STAFF REPORT: 10/12/22 REGULAR MEETING

APPLICATION NUMBER: 22-8046

ADDRESS: 1531 PARKER

SCOPE: DEMOLISH EXISTING FRONT PORCH, CONSTRUCT NEW FRONT PORCH

October 2022 site visit photo by staff.

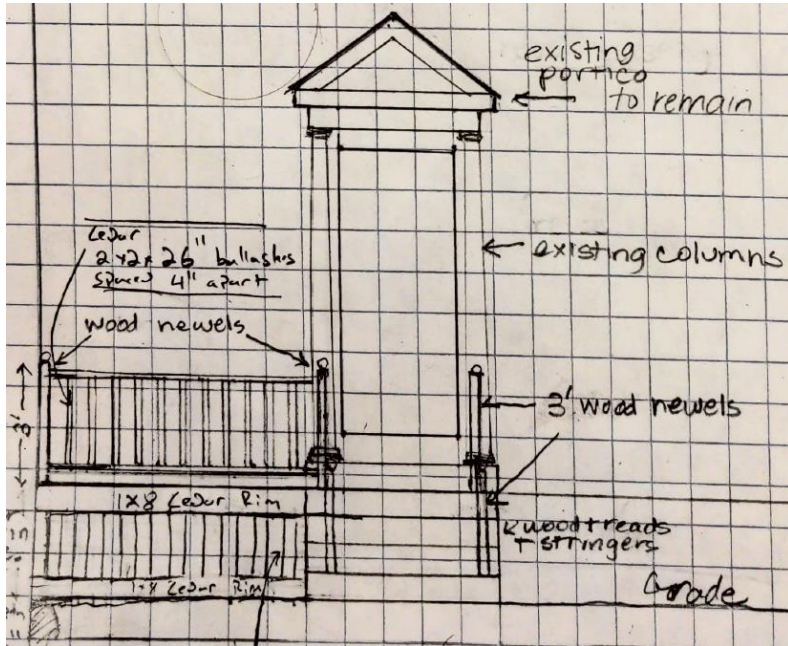
- Staff researched Sanborn maps and building permits, and visited the site, to determine if the existing porch proposed for demolition is an original, historic, or character-defining feature. Staff determined that it is not. The materials used, workmanship, the degree of weathering, and other observations suggest that it dates from the mid- to late twentieth century. As the applicant has also observed, a Sanborn map from 1950 shows a wood porch.

Front elevation of proposed porch. Sketch by applicant. Additional images are found in the application.

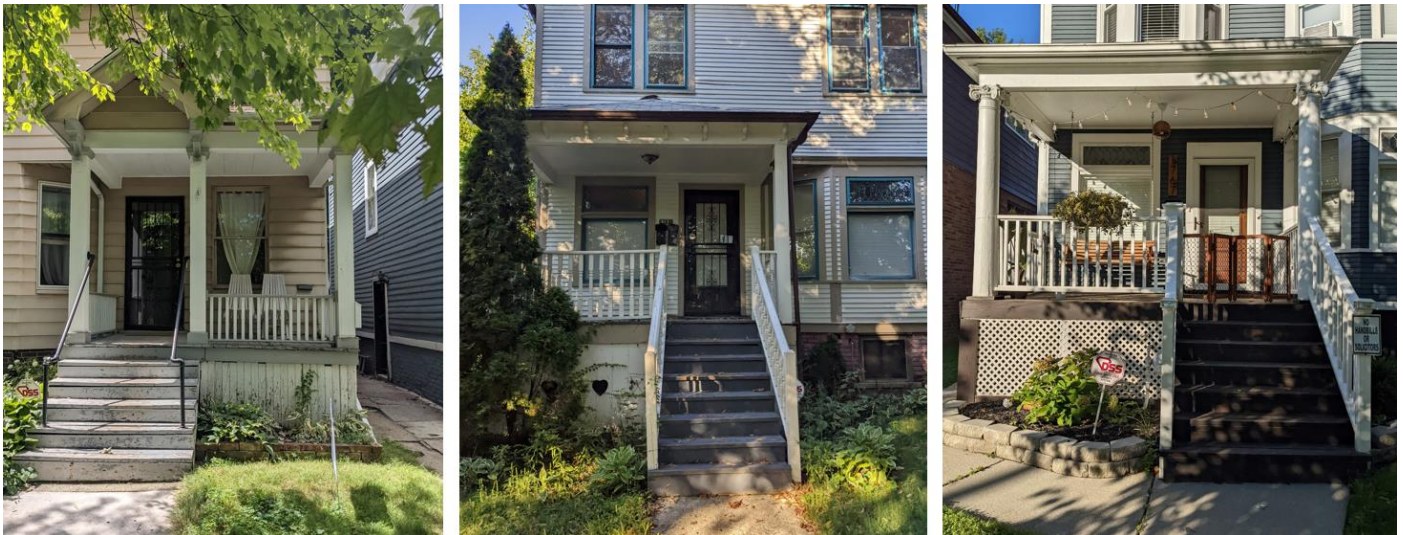
- The proposed porch reconstruction, though potentially appropriate as phase one of a broader project, would result in an uncovered wood deck, which is not a historically appropriate porch expression on a building from this period. By itself, it would create a situation that does not fit the historic character of the property (Standard #2) and is not “compatible” with the “integrity of the property its environment” (Standard #9). Uncovered stone, masonry, or concrete porches do have precedent on buildings of this age, especially in nearby Indian Village as well as Boston-Edison.

- Though restoration of lost features is not required by the *Secretary of the Interior’s Standards for Rehabilitation*, the construction of the proposed porch would partially, but not fully, reconstruct the missing historic porch. This partial reconstruction would create an incongruous appearance. (Also, an uncovered wood porch would be vulnerable to deterioration from the elements.) Staff suggests that the applicant could

- A porch roof shall be added, meeting the Secretary of the Interior’s Standards for Rehabilitation, subject to approval by staff, incorporating the historic elements still extant (i.e, the pediment and columns), which may be repositioned.
